III. Single/Multiple Element Tripping with Protection Violation

S. No.	Event	Event Analysis	Outage Date & time	Points for Review	Remedial Actions Furnished
1	400KV-TIPPAPUR-CHANDALAPUR-2	As per the reports submitted 400 kV Tippapur-Chandalapur line got tripped due to suspected earth leakage in Chandalapur end. The line got tripped at Chandalapur end. DT was sent from Chandalapur end and DT was received at Tippapur end and it tripped. As per the reports submitted 400 kV Chandalapur-Gajwel line tripped at Chandalapur end only due to earth leakage fault. No DR triggered at Gajwel end and line still in the service at Gajwel end.	16-03-2026 12:28	TGTRANSCO: 1. Tripping of the line due to DC earth leakage needs review

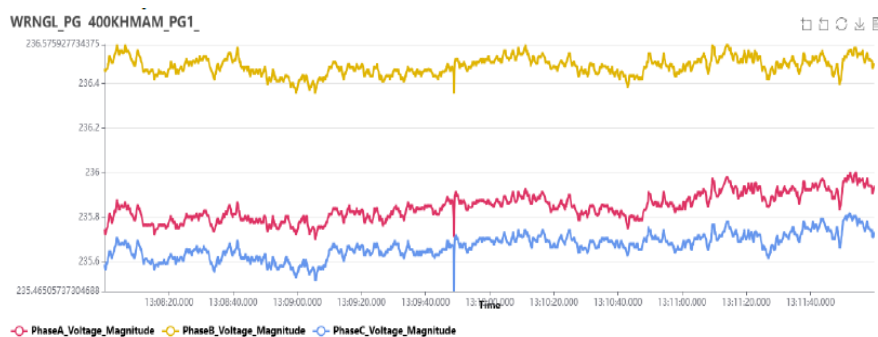
S. No.	Event	Event Analysis	Outage Date & time	Points for Review	Remedial Actions Furnished
2	400KV-GAJWEL-CHANDALAPUR-1	As per the reports submitted 400 kV Chandalapur-Gajwel line tripped at Chandalapur end only due to earth leakage fault. No DR triggered at Gajwel end and line still in the service at Gajwel end.	16-03-2026 13:10	TGTRANSCO: 1. The tripping of the line only at CHANDALAPUR due to DC earth fault need review.

➤ From the PMU data no fault is visible.

1. TGTRANSCO informed that 400 kV Tippapur-Chandalapur line tripped at Chandalapur end due to suspected earth leakage in Chandalapur was sent from Chandalapur end and. Tippapur end received DT & tripped.

2. TGTRANSCO also informed that prior to the tripping incident, it was observed that cell no 106 was opened in DC Battery-1 at Chandalapur end .
3. TGTRANSCO stated that while switching OFF the 425Ah Battery bank-1 in the DC charger-1 malfunctioning of 86A, 86B, 52XT relays were observed and multiple flickering, i.e., ON and OFF of 52XT relay was observed in C&R panel.

4. While closing the DC Bus coupler in the DCDB panel, 400kV Chandulapur-Gajwel-1 feeder tripped at Chandalapur end and TGTRANSCO stated that only due to malfunctioning of 86B trip relay, DT was received at Tippapur end.

5. As a remedial action the issue was referred to DC Charger OEM and rectified the issue by replacing the EFD relay of DC charger-1 and charged the lines.

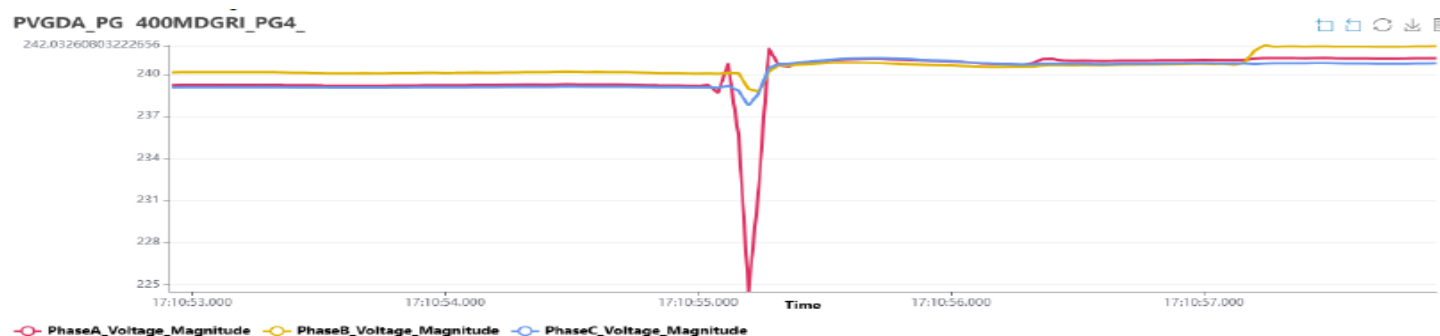
S. No.	Event	Event Analysis	Outage Date & time	Points for Review	Remedial Actions Furnished
3	Multiple Trippings at 400kV JSW Thermal of JSW	As per the reports submitted, the triggering incident is the R-G fault in 400 kV-BPS-JAGALUR-2 line. The fault was sensed at both ends in Z1 and AR operated and was successful. During the same instance, 400 kV-JINDAL-BPS-3 & 4 breakers have opened only at JINDAL end without any trip indications (as per FIR). From the DRs at JINDAL end, it can be observed that Zone 3 has started in both the lines, but trip was not issued from the relay, but the breakers opened due to suspected ground potential rise (as per FIR). It can be observed that in 400 kV-JINDAL-BPS-3 at JINDAL end, the current in the Y-ph spike of 41 kA was observed.	16-03-2026 17:10	JSW THERMAL: 1. Tripping of the 400 kV-JINDAL-BPS-3 & 4 lines at JINDAL end without any relay trip indication needs review 2. Y-ph current (secondary) spike in 400 kV-JINDAL-BPS-3 at JINDAL end needs review

➤ From the PMU data, R-G fault can be observed

1. As per the reports submitted, the triggering incident was the R-G fault in 400 kV-BPS-JAGALUR-2 line. The fault was sensed at both ends in Z1 and AR operated and was successful. During the same instance, 400 kV-JINDAL-BPS-3 & 4 breakers opened only at JINDAL end, without any trip indications (as per FIR).
2. From the DRs at JINDAL end, it can be observed that Zone 3 had started in both the lines, but trip was not issued from the relay and breakers opened due to suspected ground potential rise (as per FIR). It can be observed that in 400 kV-JINDAL-BPS-3 at JINDAL end, Y-ph current spike of 41kA was observed.
3. JSW informed that ground potential rise was recurring at 400kV Jindal-BPS.
4. It was noted that as deliberated in the additional agenda of 142nd PCSC meeting a committee would be formed to analyze the ground potential issue at 400 kV Jindal SS.

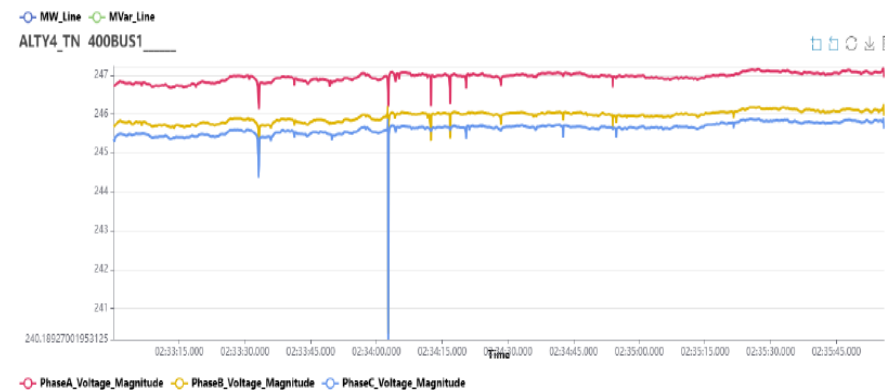
S. No.	Event	Event Analysis	Outage Date & time	Points for Review	Remedial Actions Furnished
4	400KV-ALAMATHY-SUNGAVARACHATRAM-1	As per the reports submitted, at Sungavarachatram end overvoltage was sensed and overvoltage stage 1 protection operated and voltage in Y ph is observed to be higher than other 2 phases and DT was sent from Sungavarachatram end and upon receiving the DT signal from remote end 3 phase tripping was observed at Alamathy end.	19-03-2026 02:35	<u>TANTRANSCO:</u> 1. Y ph voltages are observed to be on the higher side than other phases in the line at SUNGAVARACHATRAM end needs review

- As per the PMU data, no fault can be observed during the event.

1. As per the reports submitted, at Sungavarachatram end overvoltage was sensed and overvoltage stage 1 protection operated. Voltage in Y ph was observed to be higher than the other 2 phases and DT was sent from Sungavarachatram end and 3 phase tripping was observed at Alamathy end upon receiving the DT signal from remote end.
2. TANTRANSCO informed that as per the DR Y ph voltages were observed to be on the higher side than other phases of the line at SUNGAVARACHATRAM.
 - R phase voltage recorded as 248 kV
 - Y phase voltage recorded as 258 kV
 - B phase voltage recorded as 248 kV
3. TANTRANSCO also informed that the variation of voltage may be due to earthing issue in Line CVT.
4. SRPC advised TANTRANSCO to check the Y phase CVT earthing at 400 kV Sungavarachatram.

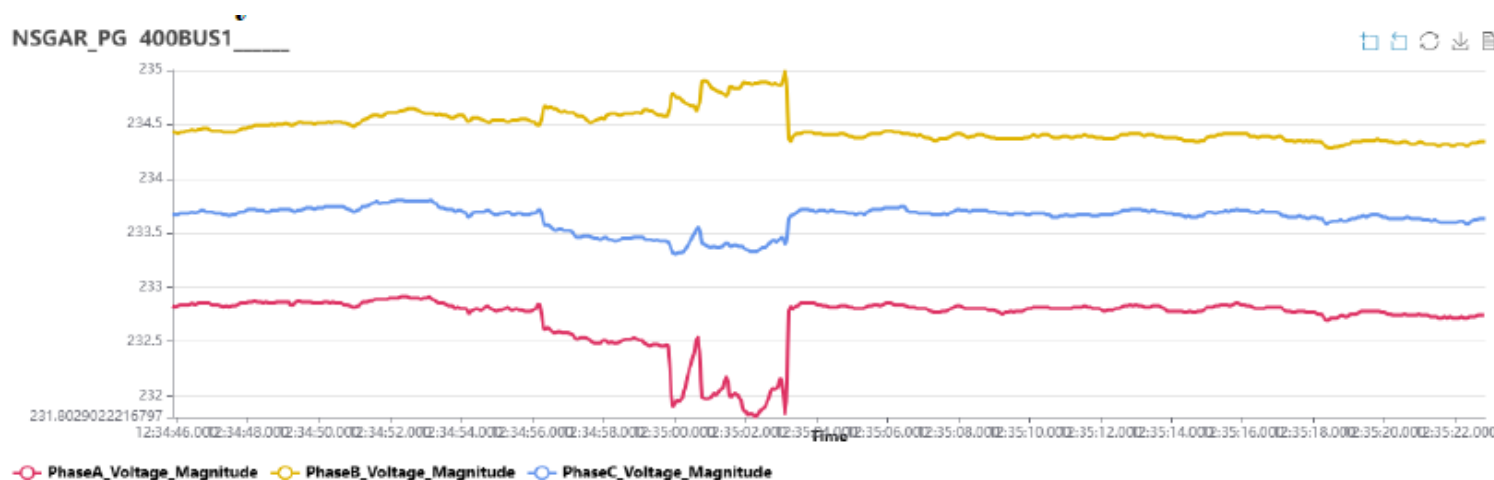
S. No.	Event	Event Analysis	Outage Date & time	Points for Review	Remedial Actions Furnished
5	220KV-SRISAILAM_RIGHT_BANK-NAGARJUNASAGAR_TS-1	As per the reports submitted the triggering incident was high resistance R-G fault in the line (based on the DR, it can be observed from R/X plot that the fault angle at Srisailam end is around 0 degrees and at Nagarjuna Sagar end the fault angle is around 13 degrees). From both the ends, DEF operated and 3 ph tripped.	26-03-2026 12:35	<u>APGENCO</u> : 1. Non configuration of DT for DEF needs review

- From the PMU data R-G fault can be observed with around 3.4s fault clearing time.

1. As per the reports submitted the triggering incident was high resistance R-G fault in the line (based on the DR, it can be observed from R/X plot that the fault angle at Srisailam end is around 0 degrees and at Nagarjuna Sagar end the fault angle is around 13 degrees). From both the ends, DEF operated and 3 ph tripped.
2. No representation by APGENCO during the deliberations of the event.
3. APGENCO to review the Non configuration of DT for DEF.
4. APGENCO to submit the detailed report on the incident.

- ❖ APGENCO to review the Non configuration of DT for DEF.

❖ APGENCO to review the Time Synch issue at N'Sagar RB

❖ APGENCO to submit the detailed report on the incident

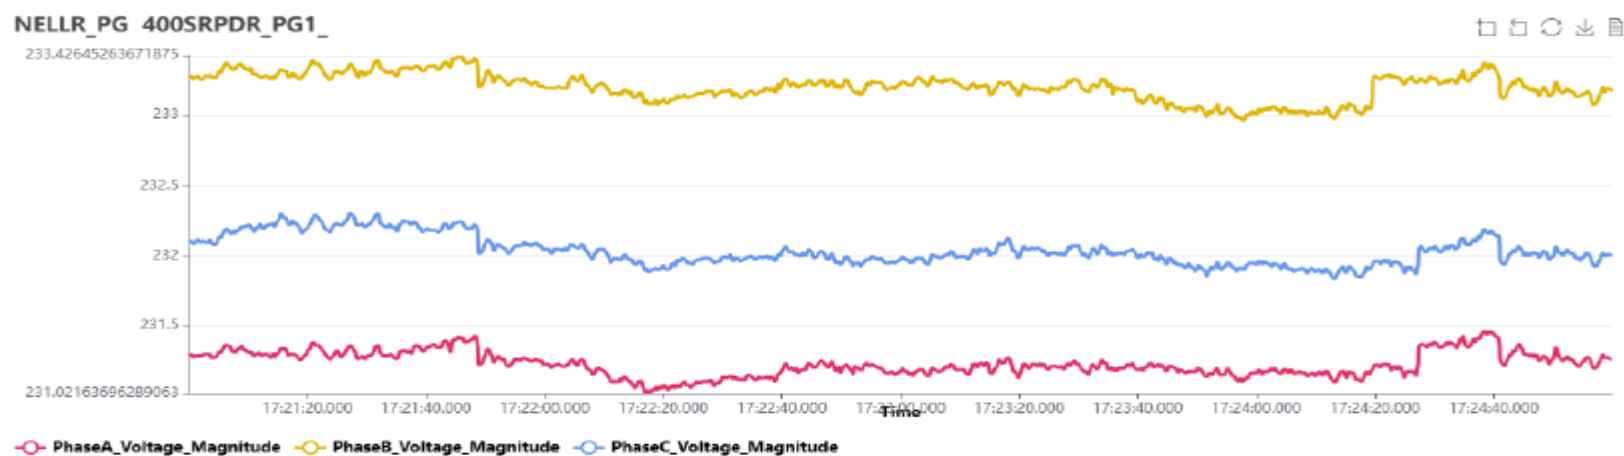
S. No.	Event	Event Analysis	Outage Date & time	Points for Review	Remedial Actions Furnished
6	400kV-KRISHNAPATNAM-SEIL_P2-1	In the antecedent condition, 409 Main CB which is connected to Bus-2 was under LC and the line was only connected through 408 Tie Breaker. As per the reports submitted, the triggering incident is the opening of Y-pole breaker without any fault in 400 kV-KRISHNAPATNAM-SEIL_P2-1 only at KRISHNAPATNAM end. After which Pole discrepancy operated after around 7.5 seconds leading to the tripping of R and B poles. This led to the 3ph tripping at KRISHNAPATNAM end. The line was holding at SEIL_P2 end.	28-03-2026 17:23	<u>APGENCO</u> : 1. Tripping of Y-ph pole without any fault needs review 2. Pole Discrepancy timer needs review

➤ From the PMU plot, there is no fault during the event.

1. As per the reports submitted, the triggering incident was the opening of Y-pole breaker without any fault in 400 kV-KRISHNAPATNAM-SEIL_P2-1 only at Krishnapatnam end. After which Pole discrepancy operated after around 7.5 seconds leading to the tripping of R and B poles. This led to the 3ph tripping at Krishnapatnam end. The line was holding at SEIL_P2 end.
2. No representation by APGENCO during the deliberations of the event.
3. APGENCO to review the tripping of Y-ph pole without any fault.

4. APGENCO to review Pole Discrepancy timer at 400 kV-KRISHNAPATNAM
5. APGENCO to submit the detailed report on the incident.

- ❖ APGENCO to review the tripping of Y-ph pole without any fault.
- ❖ APGENCO to review Pole Discrepancy timer at 400KV-KRISHNAPATNAM
- ❖ APGENCO to review the Time Synch issue at Krishnapatnam
- ❖ APGENCO to submit the detailed report on the incident.

NAGARJUNASAGAR 400kV S/S SINGLE LINE DIAGRAM

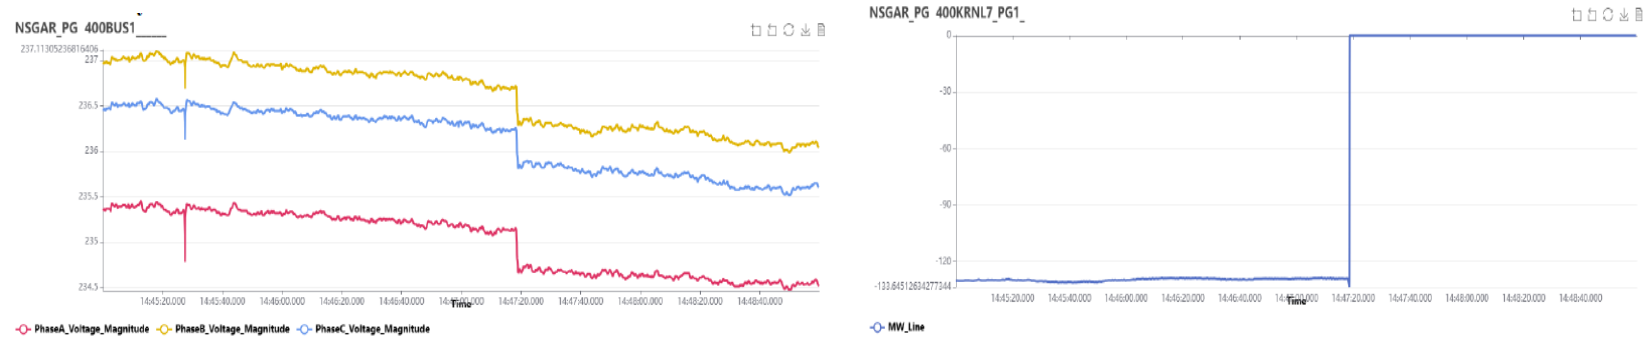
S. No.	Event	Event Analysis	Outage Date & time	Points for Review	Remedial Actions Furnished
7	400KV-KURNOOL_PG-NAGARJUNASAGAR_PG-1	As per the reports submitted, the triggering incident is the relay maloperation at NAGARJUNASAGAR_PG end and 3ph tripped and DT was sent to remote end. At Kurnool end, DT was received and 3ph trip.	02-04-2026 14:47	PGCIL SR-1: 1. Tripping of the line at NAGARJUNASAGAR_PG end due to relay maloperation needs review

- From the PMU plot, it can be observed that there is no fault during the event.

1. As per the reports submitted, the triggering incident was the relay maloperation at NAGARJUNASAGAR_PG end resulting in 3ph tripping and DT was sent to remote end. At Kurnool end, DT was received and all 3 phases were tripped.
2. PGCIL SR-I informed that as per the DR, there was no fault current and all the Voltages and currents were normal before tripping. Only indication was Group A/B operated.
3. PGCIL SR-I also informed Physical inspection of Switchyard was carried out and no abnormality was noticed.
4. As per the local relay flags, Group-A operated was found and the relay found in High condition after tripping. Finally, it was found that the Group-A pickup coil was failed.
5. PGCIL SR-I informed that failed Group-A pickup relay was replaced by a spare relay and checked. GR-A relay operation was observed normal. Line was taken Into Service after replacement of Relay.

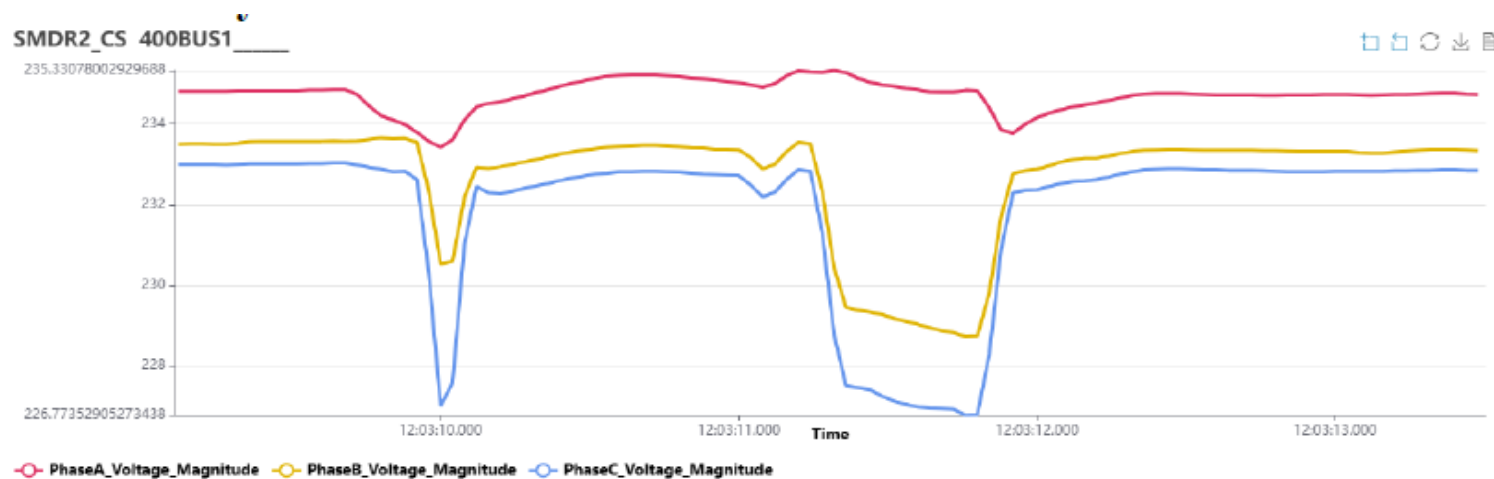
S. No.	Event	Event Analysis	Outage Date & time	Points for Review	Remedial Actions Furnished
8	400KV-KALPAKKA-ASUPAKA-1	As per the reports submitted, the triggering incident was B-G fault in the line. At Asupaka end, the fault was sensed in zone-1 and B-pole opened. After around 1000ms, A/R operated and the fault was sensed again in zone-1 and line tripped on persistent fault with no delay. At KALPAKKA end, the fault was sensed in carrier aided zone-2 and B-pole opened. After around 1200ms, A/R operated and the fault was sensed in zone-2 and the line tripped with a delay of 560ms.	03-04-2026 12:03	<p>APTRANSCO: 1. Non operation of SOTF at Kalpakka end after A/R operation.</p> <p>2. Difference in A/R dead time between Kalpakka and Asupaka end.</p> <p>TGTRANSCO: 1. Difference in A/R dead time between Kalpakka and Asupaka end.</p>

➤ From the PMU plot, B-G fault can be observed during the event with a delay of around 560ms after the A/R operation.

1. As per the reports submitted, the triggering incident was B-G fault in the line. At Asupaka end, the fault was sensed in Zone-1 and B-pole opened. After around 1000ms, A/R operated and the fault was sensed again in Zone-1 and line tripped on persistent fault with no delay. At KALPAKKA end, the fault was sensed in carrier aided Zone-2 and B-pole opened. After around 1200ms, A/R operated and the fault was sensed in zone-2 and the line tripped with a delay of 560ms
2. APTRANSCO informed that at Kalpakka end, ZCOM protection operated for B-ph fault in the line and B-Ph CB was opened. After dead time, B-Ph CB was reclosed on the fault, SOTF/TOR not operated and hence Zone-2 started and the line was tripped after Zone-2 time.
3. APTRANSCO stated that non-operation of SOTF/TOR during zone 2 pickup was addressed to OEM.

4. APTRANSCO also informed that AR feature was enabled in Siemens BCU with dead time of 1 sec., while AR operations during the reclose of breaker, the AR close command is being issued with 100 to 150 mS delay. The same was raised to M/s Siemens and was being pursued with M/s Siemens for proper operation of AR.
5. SRPC advised APTRANSCO to submit the detailed OEM report on the AR operation at Kalpakka.

- ❖ APTRANSCO to submit the detailed OEM report on the AR operation at Kalpakka.

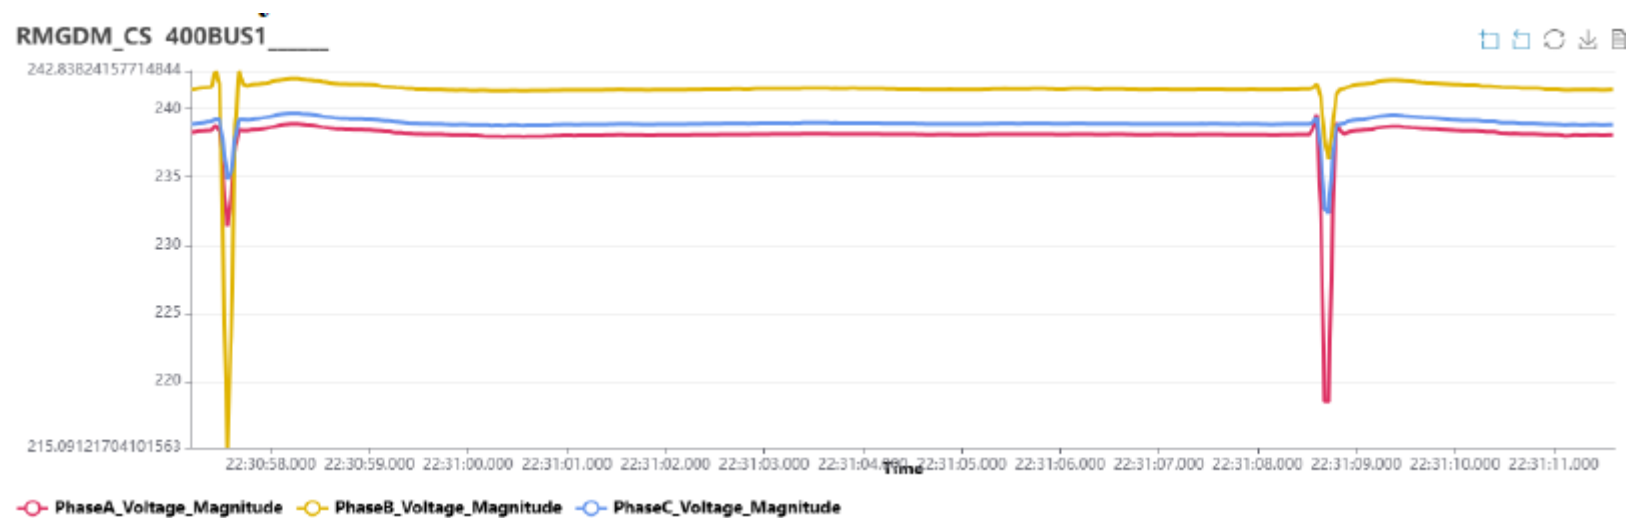
S. No.	Event	Event Analysis	Outage Date & time	Points for Review	Remedial Actions Furnished
9	400KV-DICHPALLY-NIZAMABAD-1	During the fault at Nirmal substation due to inclement weather, 400 kV-DICHPALLY-NIZAMABAD-1 line tripped only at NIZAMABAD end.	04-04-2026 22:31	PGCIL SR-1 : Tripping of the line only at NIZAMABAD end needs review

- From the PMU plot, Y-G fault followed by R-G fault can be observed.

1. PGCIL SR-I informed that 400 kV Nizamabad- Dichpally line-1 tripped only at Nizamabad end on 04.04.2026 at 22:31:16Hrs. 400kV Dichpally 1 Line (4.4KMs) is between PGCIL Nizamabad Station and TGTRANSCO Dichpally Station.

- **Incidence 2:** At 22:31:16Hrs, another single-phase R-G fault was detected in Zone-1 by main-1(P444) relay. As the fault occurred during reclaim time, the line tripped at Nizamabad end.

4. PGCIL SR-I stated that during both instances, the main-1 (P444) relay operated and resulted in tripping of Nizamabad- Dichpally line, for remote station faults.

5. After the incident PGCIL SR-I requested PCSC forum for increasing the time of operation of Zone-1 to 100 ms to avoid the distance protection operation for the remote end faults.

6. SRPC mentioned that as per the **Schedule-V of the CEA Technical Standards for Construction of Electrical Plants Lines Regulations 2022-23** for short lines (length less than 10 km) of 220kV and above, line differential protection shall be used with built-in backup distance protection in both main-I and main-II.

9. PCSC forum informed that as per grid code fault clearing time for the 400 kV and 765 kV transmission lines must be less than 100msec and hence PCSC forum advised PGCIL SR-I to comply with the grid code and avoid intentional delay of 100msec for zone-1 distance protection.

7. Hence, forum advised PGCIL SR-I to implement line differential protection with both built-in backup distance protection in main-I and main-II relays. PGCIL SR-I agreed for the same.

- ❖ PGCIL SR-I was advised to implement line differential protection with both built-in backup distance protection in main-I and main-II relays in 400KV-DICHPALLY-NIZAMABAD-1.
- ❖ PCSC forum advised PGCIL SR-I to comply with the grid code and avoid intentional delay of 100msec for zone-1 distance protection.
- ❖ PGCIL SR-I to provide the detailed report on the incident.

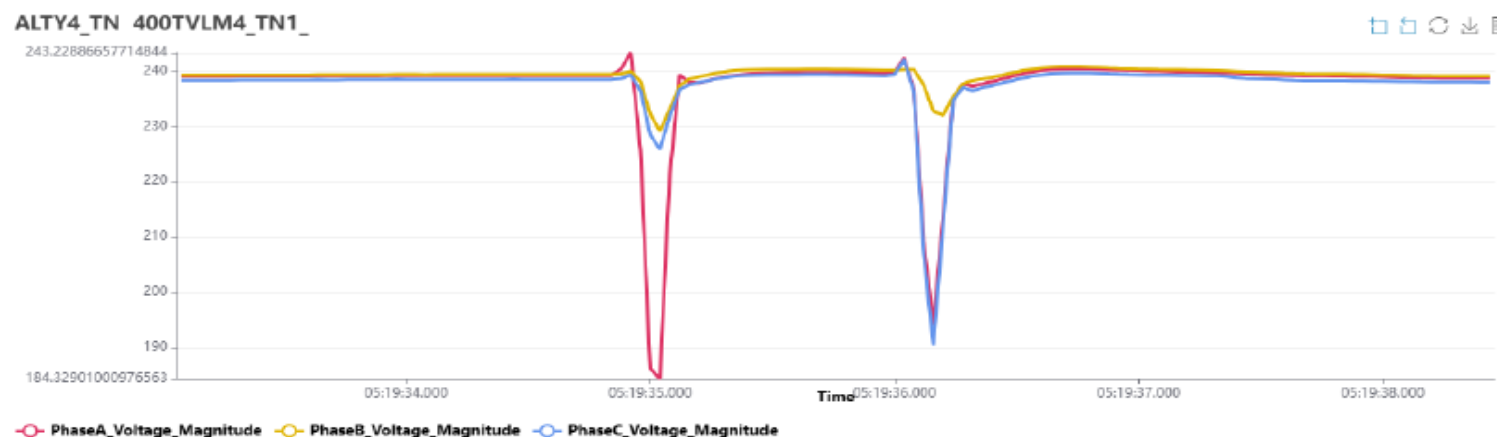
S. No.	Event	Event Analysis	Outage Date & time	Points for Review	Remedial Actions Furnished
10	400KV-MANALI-PULIYANTHOPE-2 Jumper cut event	As per the reports submitted, the triggering incident was R Phase Pilot Suspension Insulator flash over at Location No.8 from Manali end. At Manali end, the fault was sensed in line differential protection and R-pole of Main CB and Tie CB opened. After 1s, main CB A/R operated and all 3 poles of Main CB tripped on persistent R-B fault. However, Tie CB A/R did not operate by that time and Y and B-poles of Tie CB were closed. After 2.5s from the fault inception, Tie CB Y and B-poles opened on suspected pole discrepancy. At puliyanthope end, the fault was sensed in line differential protection, and R-pole of Main CB and Tie CB opened. After 1s, main CB A/R operated and all 3 poles of Main CB and Tie CB tripped on R-B persistent fault.	06-04-2026 05:20	TANTRANSCO: 1. Non operation of Tie CB A/R at Manali end

➤ From PMU, R-G fault followed by an RB fault is observed during the event with no delayed fault clearance.

1. The triggering incident was R Phase Pilot Suspension Insulator flash over at Location No.8 from Manali end. At Manali end, the fault was sensed in line differential protection and R-pole of Main CB and Tie CB opened. After 1s, main CB A/R operated and all 3 poles of Main CB tripped on persistent R-B fault. However, Tie CB A/R did not operate by that time and Y and B-poles of Tie CB were closed. After 2.5s from the fault inception, Tie CB Y and B-poles opened on suspected pole discrepancy.

2. At Puliyanthope end, the fault was sensed in line differential protection, and R-pole of Main CB and Tie CB opened. After 1s, main CB A/R operated and all 3 poles of Main CB and Tie CB tripped on R-B persistent fault.

3. TANTRANSCO informed that upon analyzing the event TANTRANSCO found the erratic initiation in the F50 relay of Tie CB because of that Auto Reclosure lockout was initiated and subsequently F50 relay was rectified.

4. TANTRANSCO further informed that after the incident TANTRANSCO disabled the Auto Reclosure function in Tie CB, 400KV-MANALI-PULIYANTHOPE- 1&2 as both the lines are composite conductors.
